Reference: Carbon Footprint Review, State Street Crossing Units 4, 5, & 6

Stantec has evaluated the carbon footprint of two (2) alternative site layouts for State Street Crossing Units 4, 5, & 6. The Township has received an application to develop the three (3) units as a multiple tenant commercial space. Unit 4 is encumbered with a conservation easement for protection of existing trees. The conservation easement was placed on this parcel as part of the State Street Crossings Final Site Plan approved in 2003. Originally, the applicant had submitted two (2) site plans with two independent building sites, one (1) located on Unit 4 and one (1) on Units 5 & 6 with associated parking. This configuration works around the existing easement. This development of the units is referred to as Site Plan A. Working with the Township Planning Consultant to address planning concerns, the applicant prepared and submitted for approval an alternative layout to combine and develop all three (3) outlots as a cohesive development. This combined layout is referred to as Site Plan B. This configuration reduces the size of the existing "on-site" conservation easement and mitigates trees both "on-site and

Adjacent Connections Site Plan A

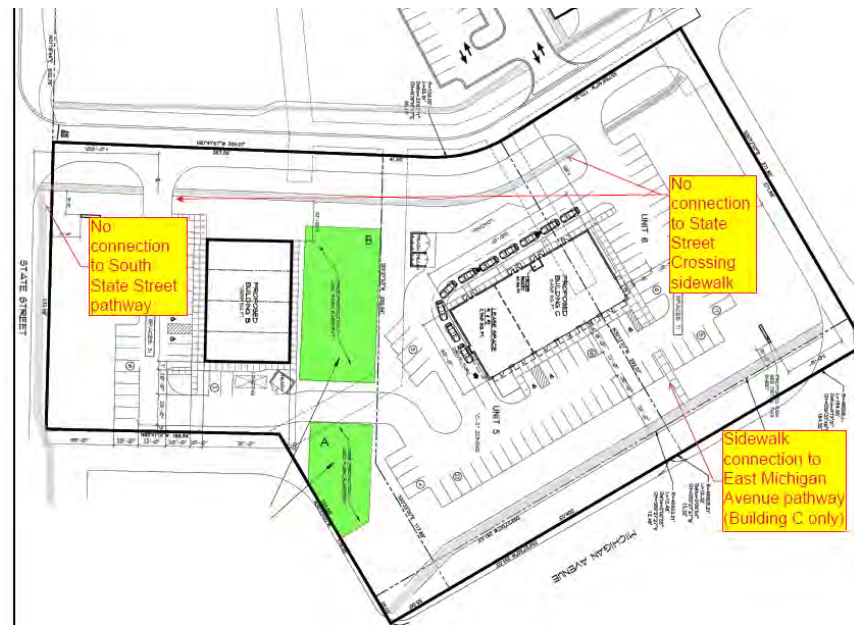
B. Ease of adjacent movement: Does the site encourage walking or biking, i.e. how likely is someone to walk/bike to or from the site from the nearby neighborhoods or adjacent commercial uses? There are existing pathways/sidewalks along East Michigan Avenue, South State Street and the interior State Street Crossing drive to the north. We looked at the access to these walks. As illustrated below, Site Plan A provides connection to the pathway along East Michigan Avenue for one of the two buildings. There is no sidewalk connection to the State Street Crossing sidewalk or the State Street pathway.

Adjacent Connections Site Plan B

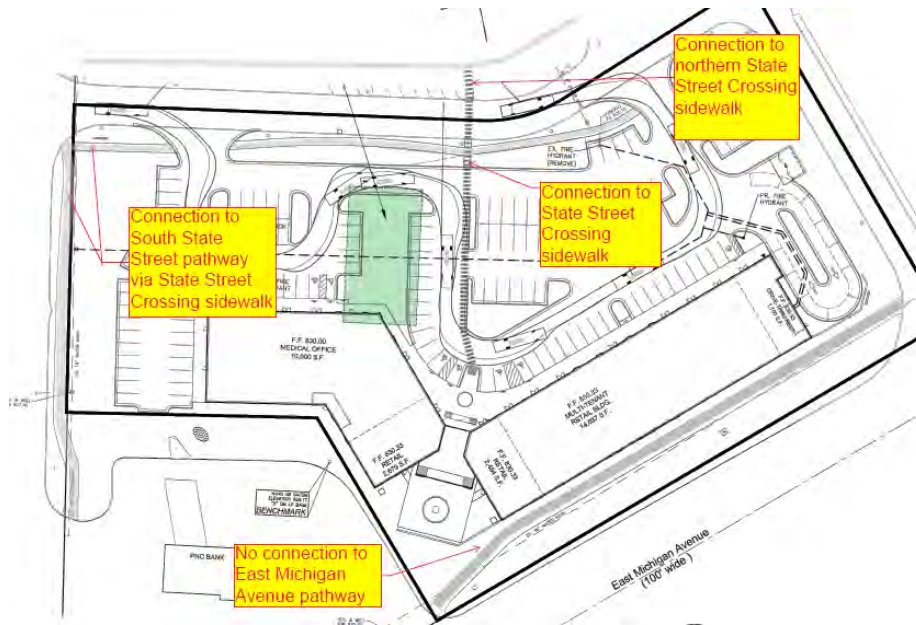
Site Plan B provides sidewalk connections to both buildings as illustrated below. This connects to the State Street Crossing sidewalk. A connection is provided to the South State Street pathway following this sidewalk to the west. There will also be sidewalk connection to the north State Street Crossing sidewalk which connects to the existing buildings on Unit 2. The southern State Street Crossing sidewalk is to be re-built to allow for raingardens/green infrastructure between the road and parking lot. Furthermore, the plaza on Site Plan B is less than 30 feet from the walk along East Michigan Avenue, so a direct sidewalk connection could be incorporated. With this additional sidewalk, Site Plan B would be more encouraging of adjacent non-motorized movement.
